Meeting Minutes

PROJECT: City of Edina – 7001 York Development Community Engagement
HGA Commission Number 3957-002-00
FROM: Mia Blanchett, Amanda Henderson WRITER'S DIRECT DIAL 612-758-4233
DATE: February 3, 2017

Purpose: Preliminary Site Options - Public Open House
Date: January 12, 2017 **Time:** 6:00 - 8:00 p.m.
Location: Southdale Library Meeting Room

INITIAL CONCEPT SKETCH 01

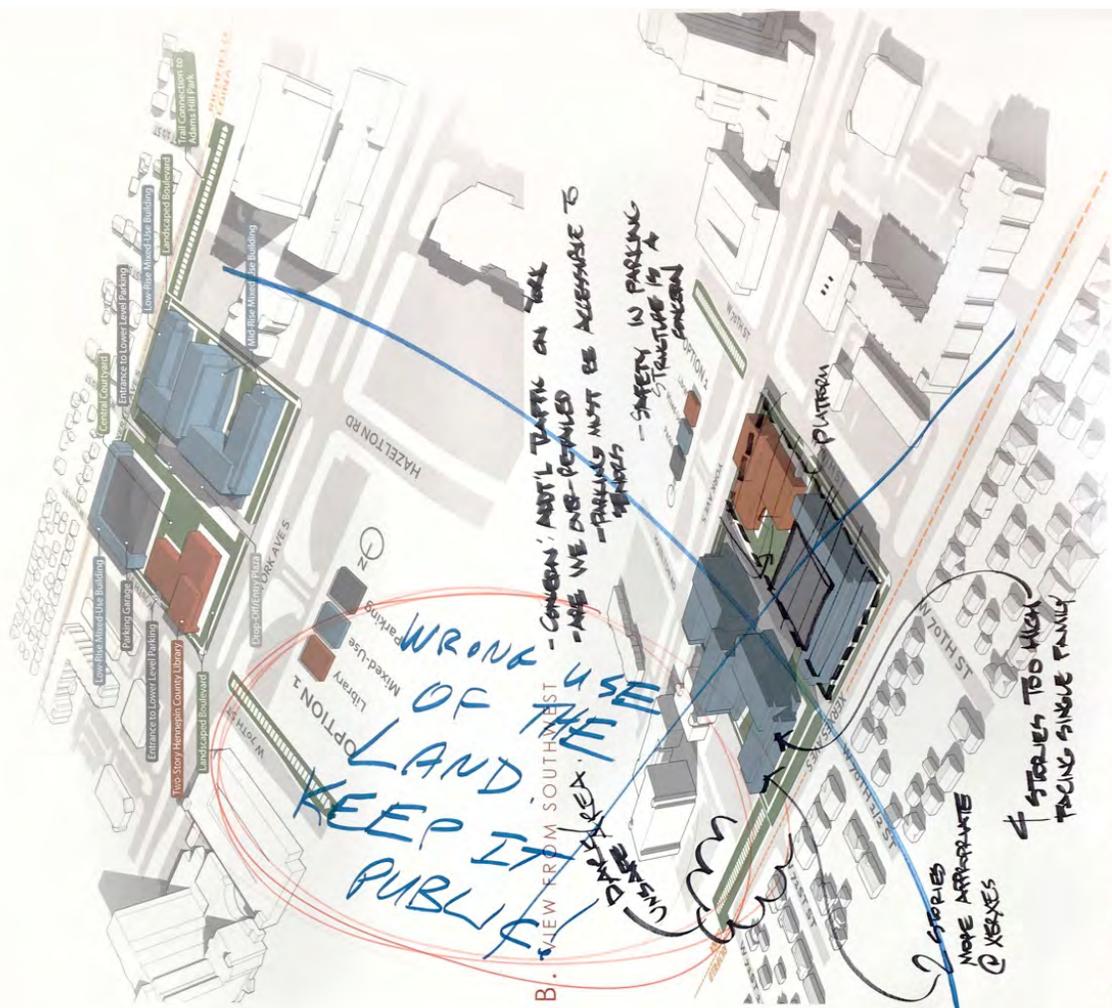
WRONG USE OF LAND KEEP IT PUBLIC

CONCERN: NOT'IL TRAFFIC ON YORK
ARE WE DIS-PELLED
PARKING MUST BE ACCESSIBLE TO

SURETY IN PARKING STRUCTURE IN A CONCERN

2 STORIES MORE APPROPRIATE @ XERXES

STORIES TOO HIGH TACING SINGLE FAMILY

INITIAL CONCEPT SKETCH 01

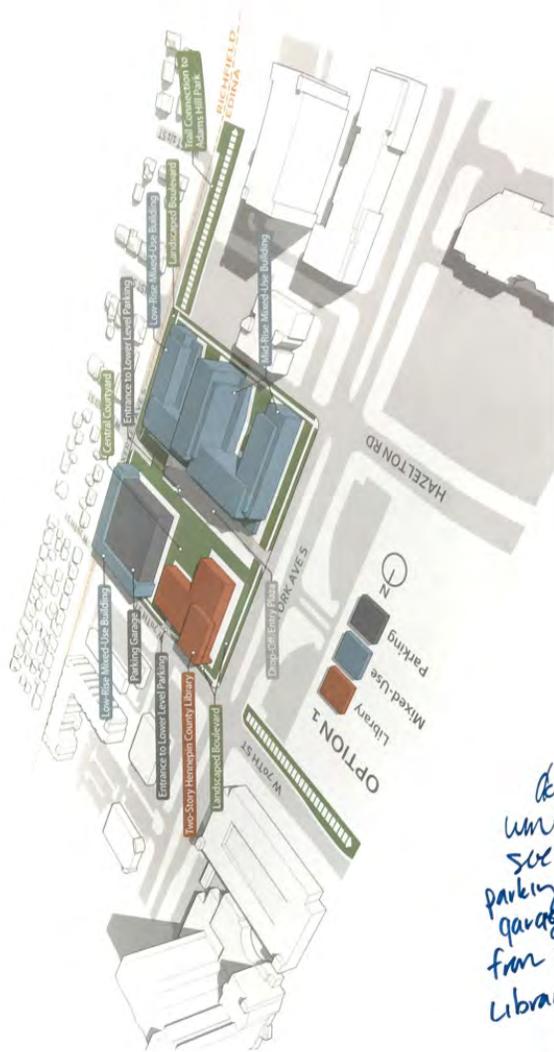
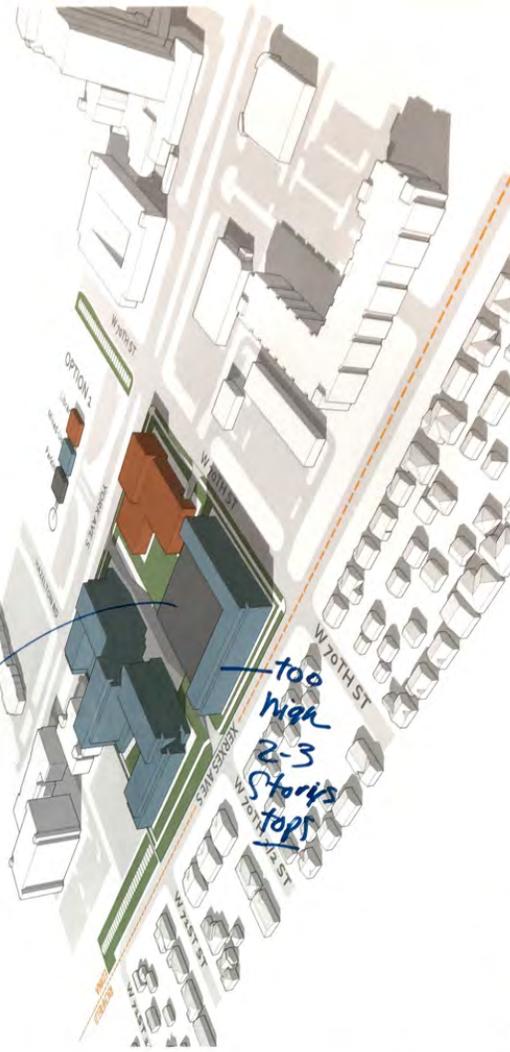
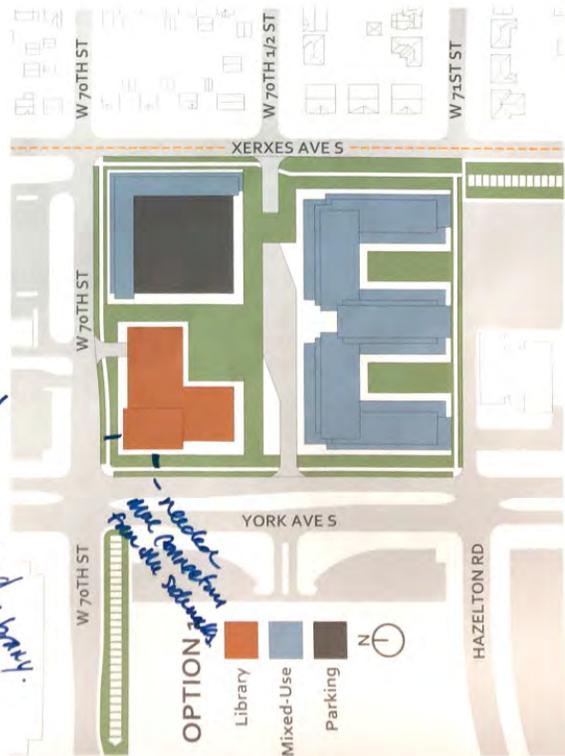
Don't want to see a parking garage from the library.

too high 2-3 story tops

+ like the entrance from Xerxes + connected neighborhood

+ stand alone library.

- reader - need to connect from the sidewalk

INITIAL CONCEPT SKETCH 01

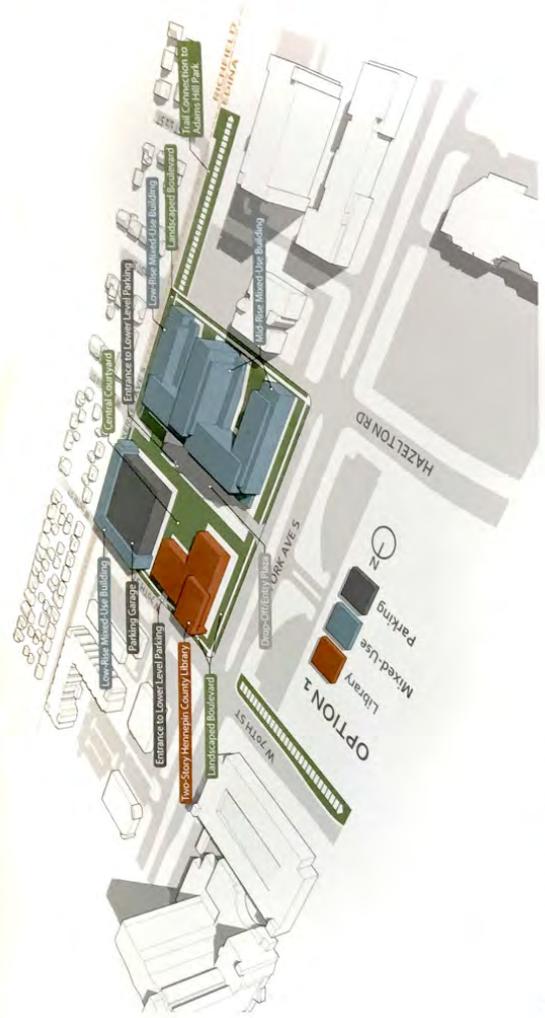
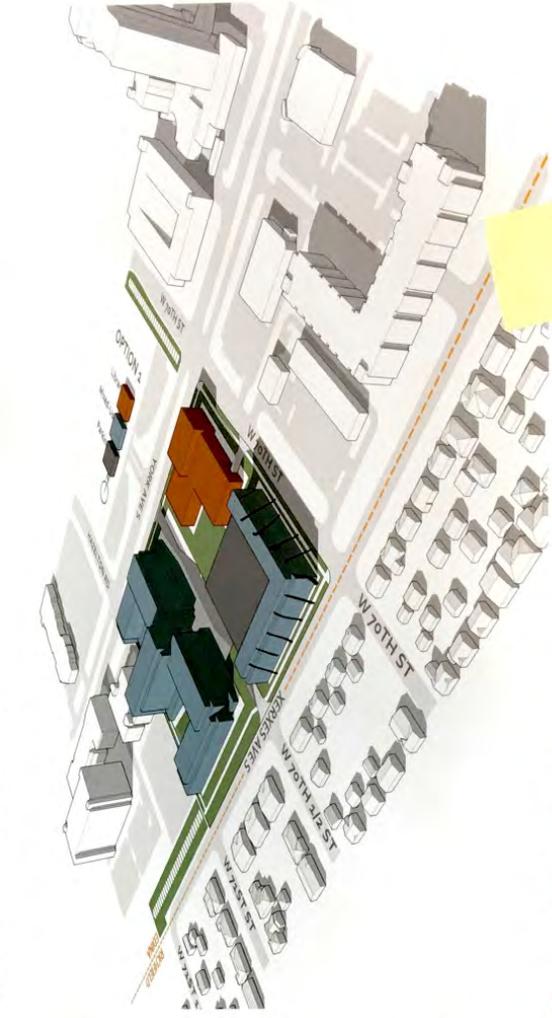
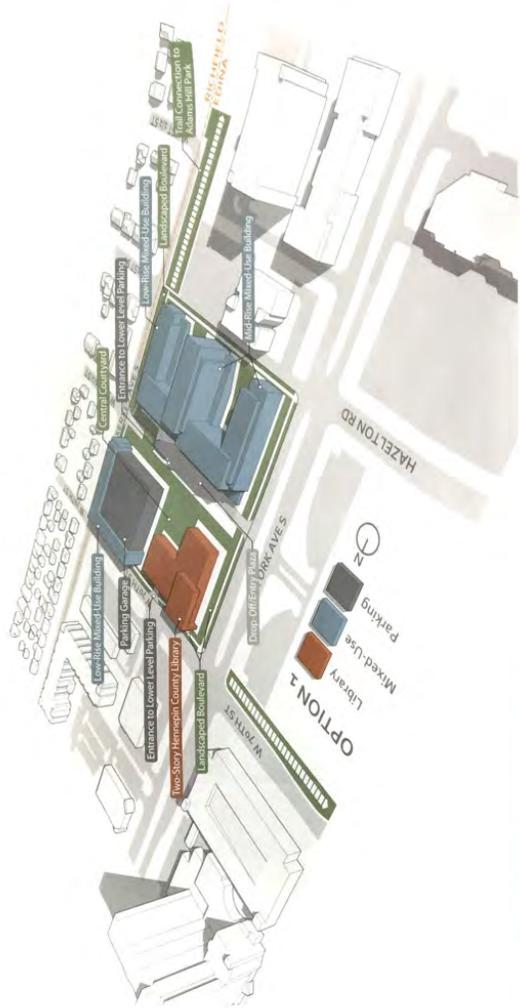
Natural Light

INITIAL CONCEPT SKETCH 01

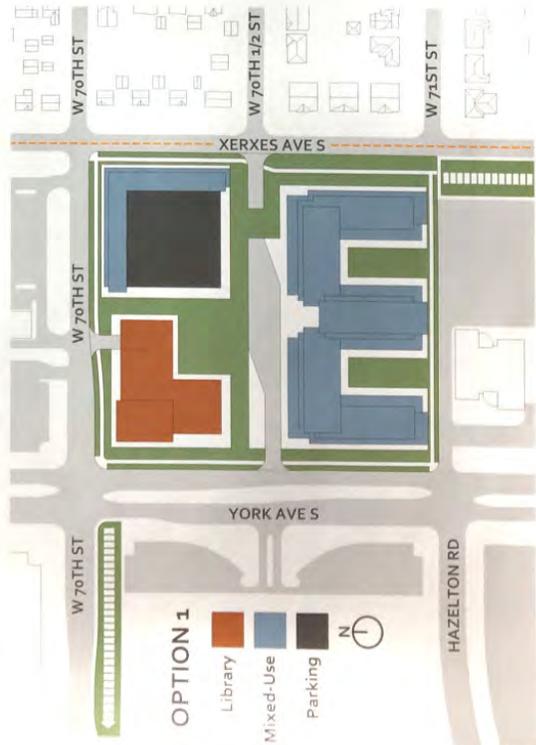
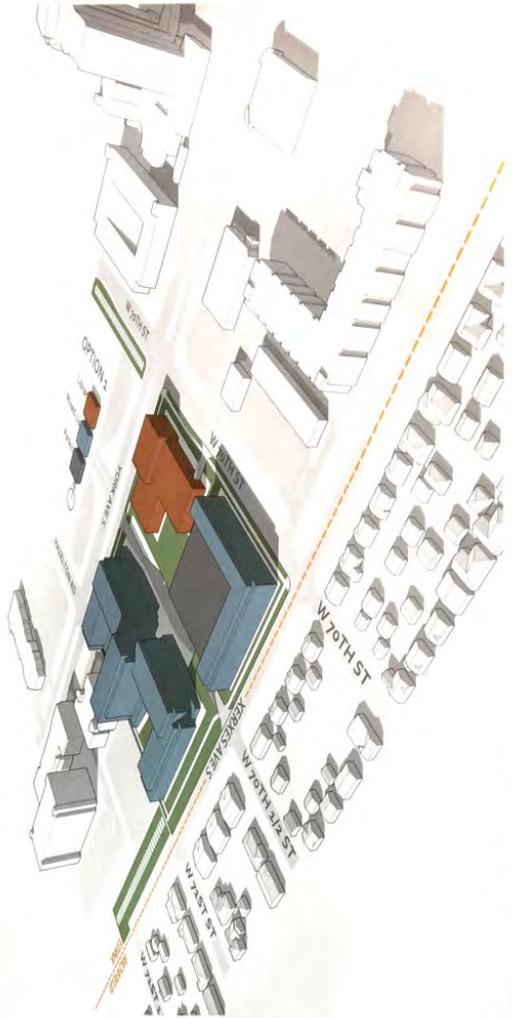
- ① Library MUST STAND ALONE
- ② Cultural Art Space
- ③ Low Rise!
- ④ More Green space
- ⑤ Public Amenity
- ⑥ All parking Underground

INITIAL CONCEPT SKETCH 02

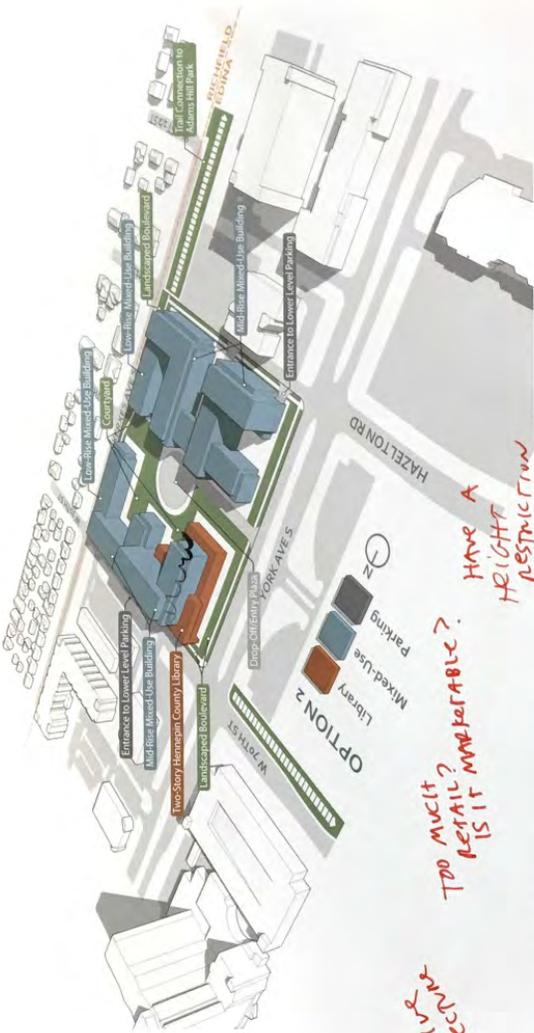
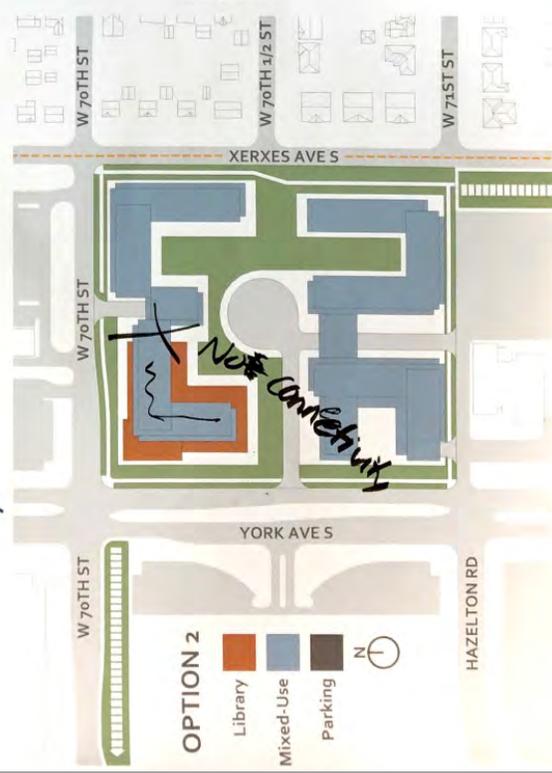
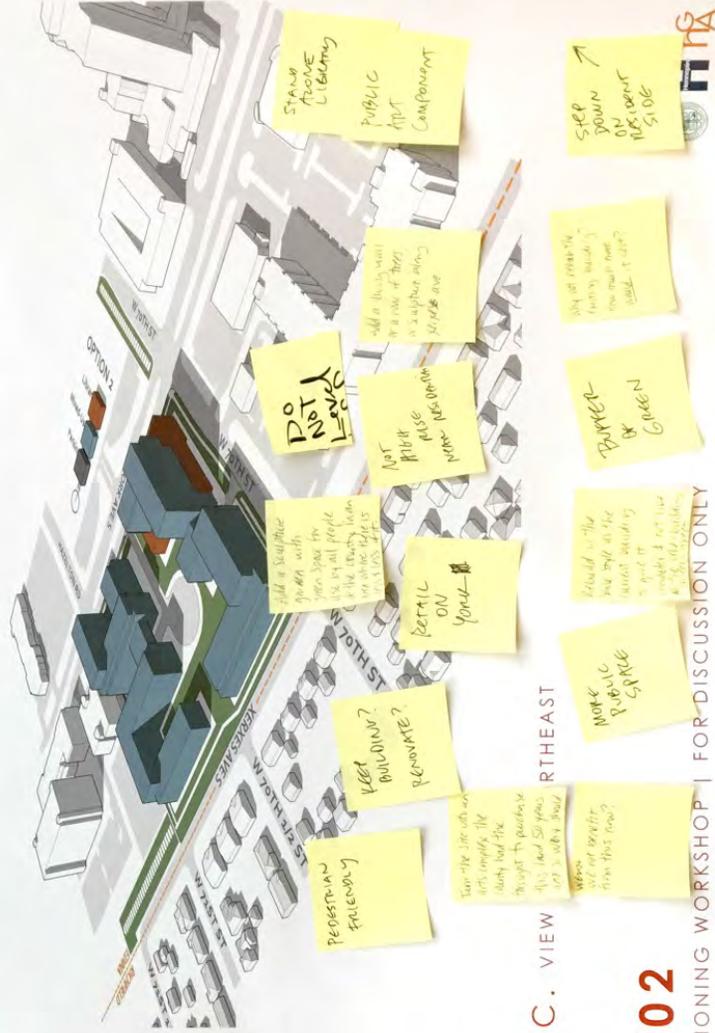
Iconic Building / Distinctive Architecture

TOO MUCH? RETAIL? IS IT MARKETABLE?

HAVE A BRIGHT RESTRICTION

Have nothing attached to L. library

Not connected

PEDESTRIAN FRIENDLY

RENOVATE? REBUILD?

RETAIL ON YORK

NOT MAKE PASSAGE MORE VISIBILE

STAND ABOVE LIBRARY PUBLIC ART COMPONENT

WORK PUBLIC SPACE

STEP DOWN ON YORK SIDE

REPAIR SITE WITH ARTS CENTER. THE DUMPY HAD THE THOUGHT TO REPAIR WITH ARTS CENTER.

THOUGHT TO THE PUBLIC BUILDING. IS THERE A POSSIBILITY OF NOT HAVING A PUBLIC BUILDING?

INITIAL CONCEPT SKETCH 03

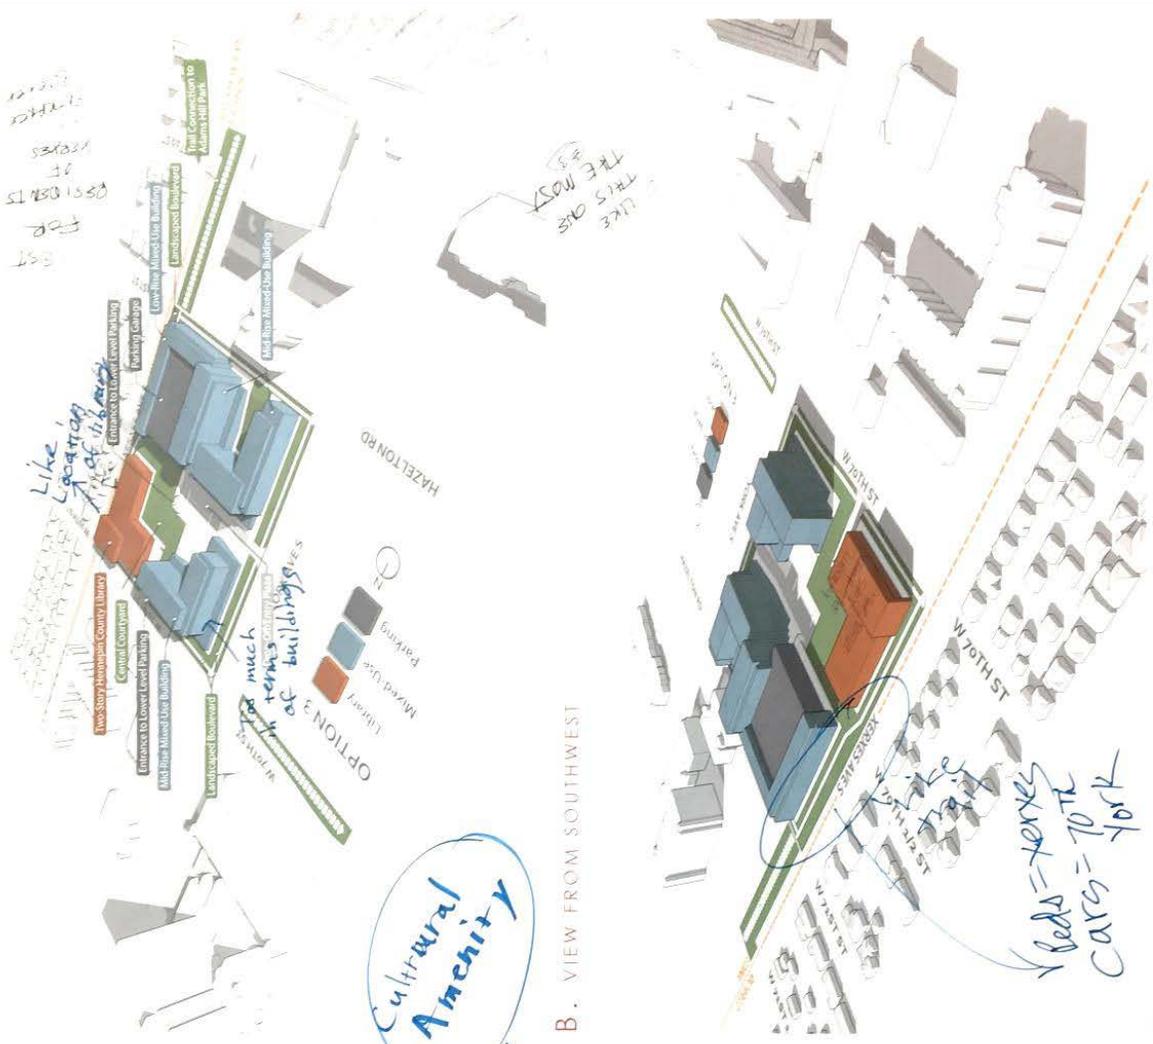
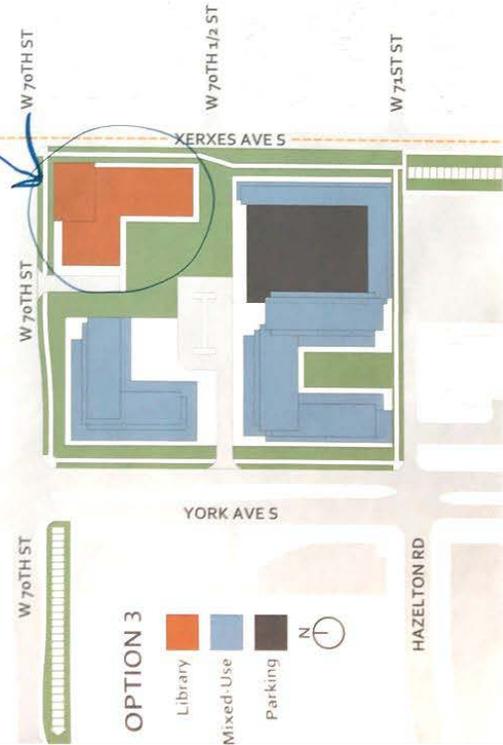
Cultural Amenity

INITIAL CONCEPT SKETCH 03

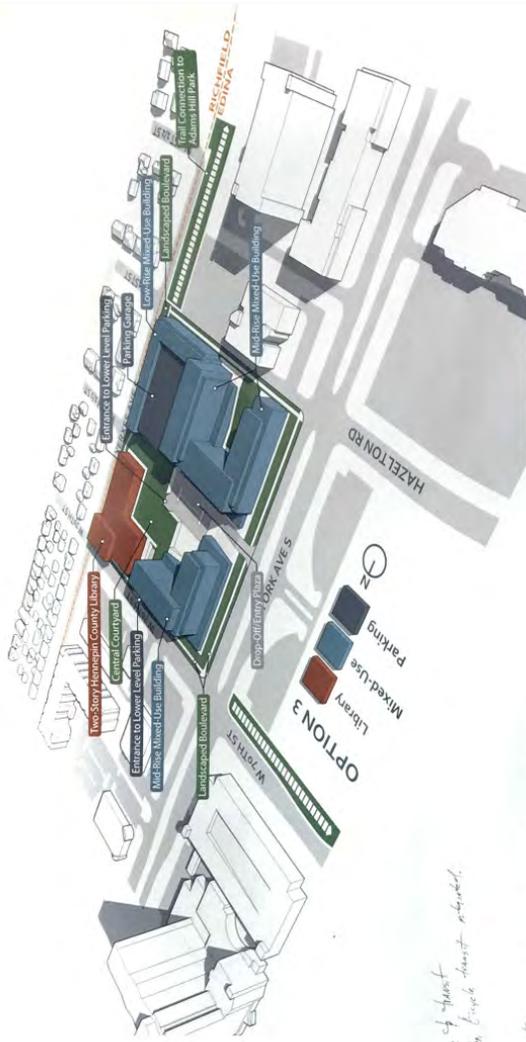
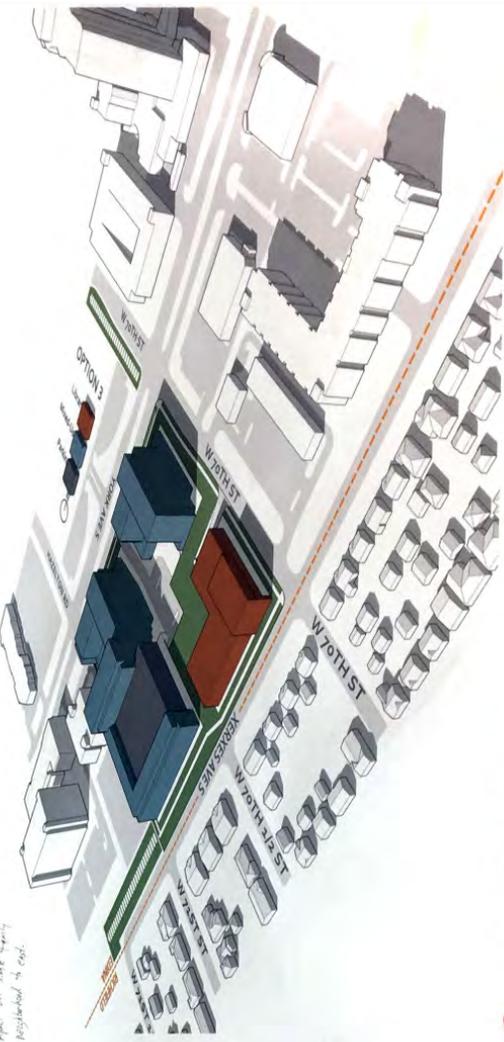
*No reference of height
 - The sun, bright doesn't stand out.*

*Good library placement
 Downtown location
 Low road for high visibility
 At 2:30pm less
 Impact on bank already
 Neighborhood is east.*

*Should provide signage for the library to the public
 Higher visibility signage*

*Mixing in
 Green Scavals*

INITIAL CONCEPT SKETCH 03

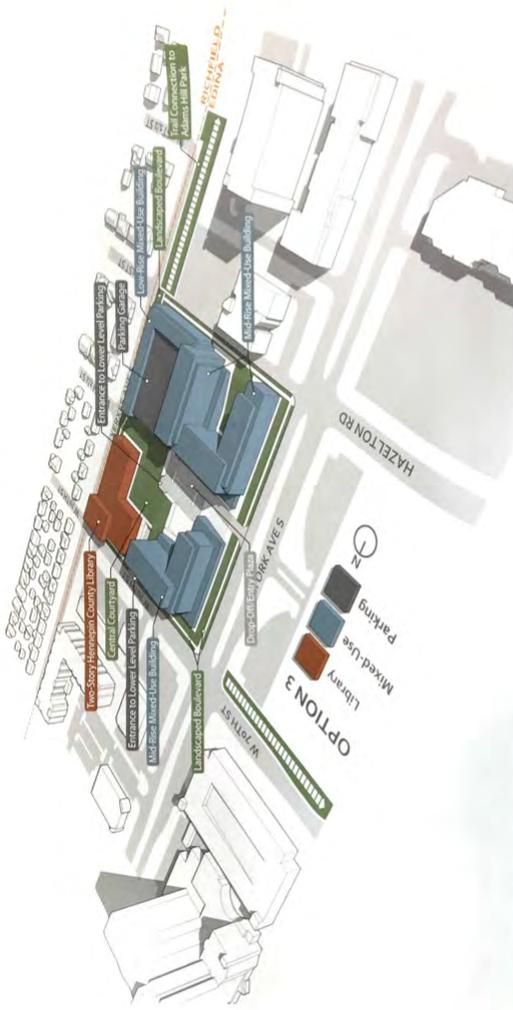
Need community center - 4000 sq ft

Don't build over it! stories!

Food/Drink near front parking

Prepare parking underground. No visible signage

Heavy restriction on building height (you can't build anything taller than 4 stories)

Make Site Design Desert look like every other building in the area
